CITY OF ALBUQUERQUE

**RE: Randolph Road Project
Grading and Drainage Plan
Engineer's Stamp Date: 05/28/19
Hydrology File: M15D046**

Randolph Road Project

GRADING & DRAINAGE PLAN

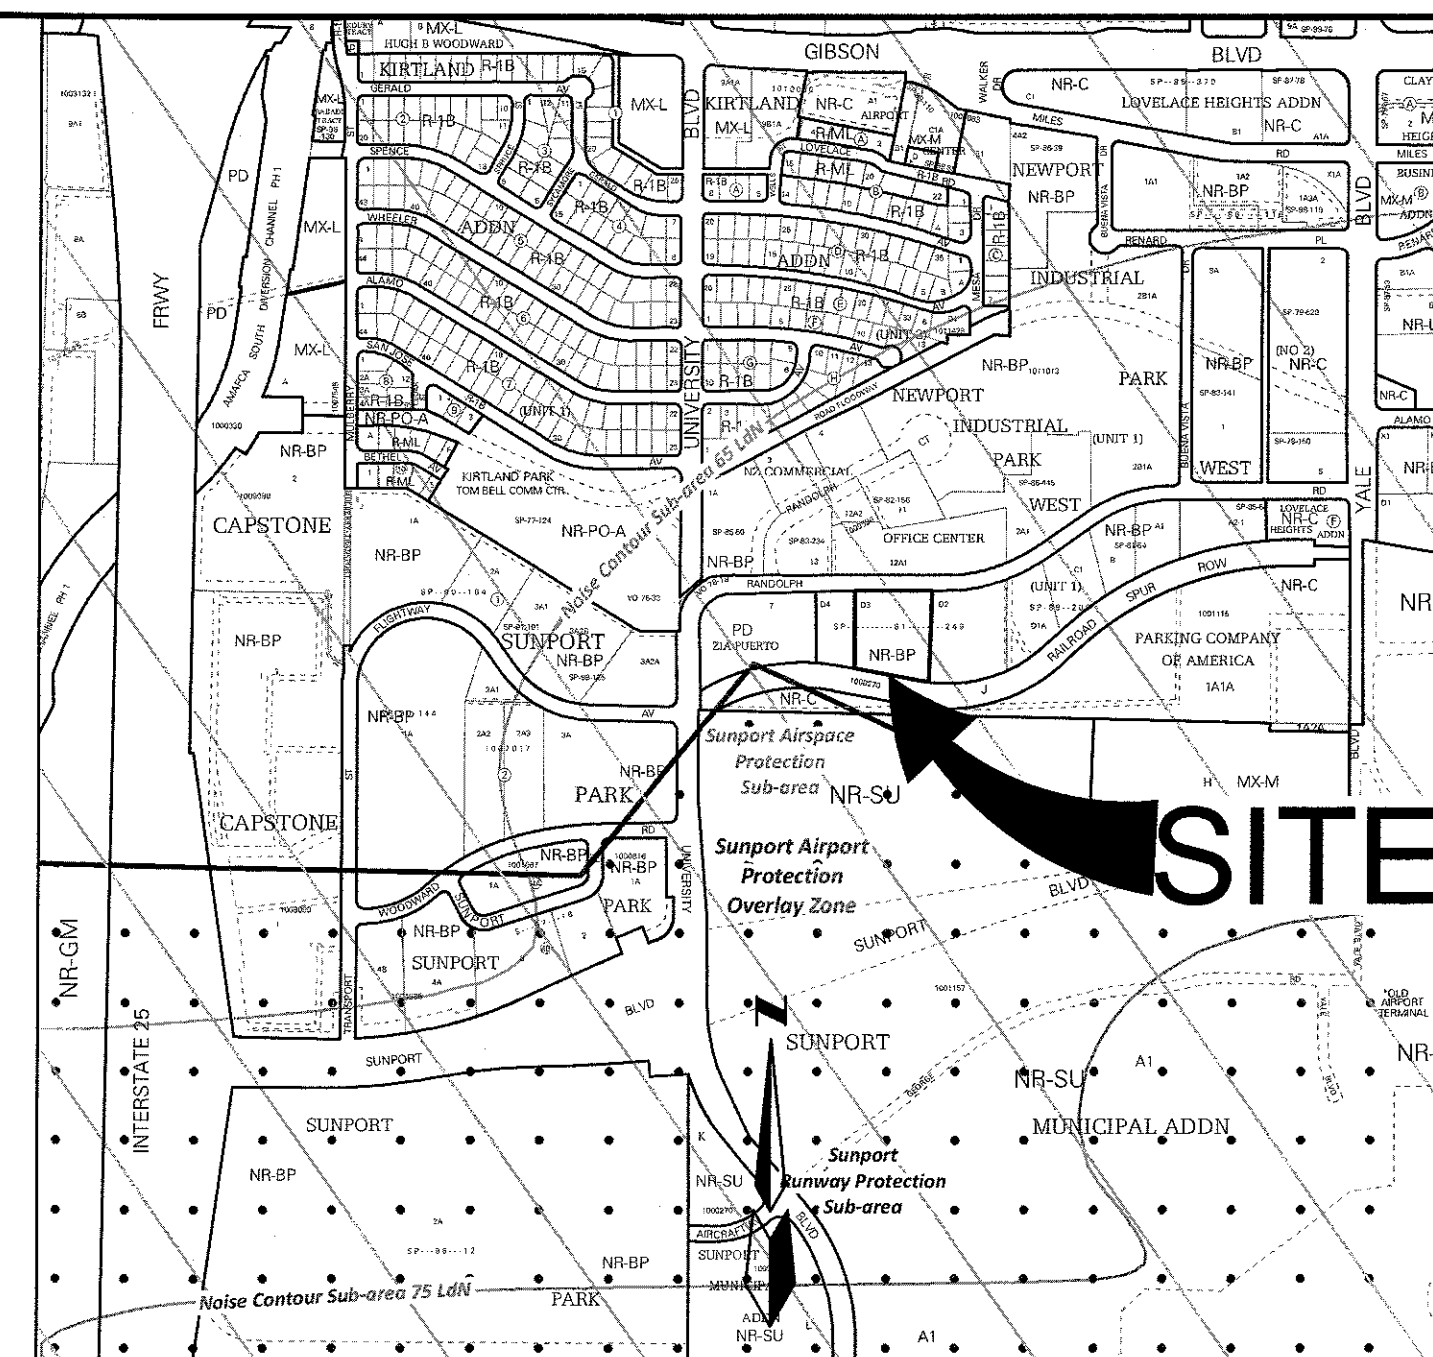
Based upon the information provided in your submittal received 05/29/2019, the Grading and Drainage Plan is approved for Paving Permit and Grading Permit.

Please provide a Drainage Covenant per Chapter 17 of the DPM for Stormwater Quality pond as soon as possible. Please submit this on the 4th floor of Plaza de Sol. A \$25 fee will be required.
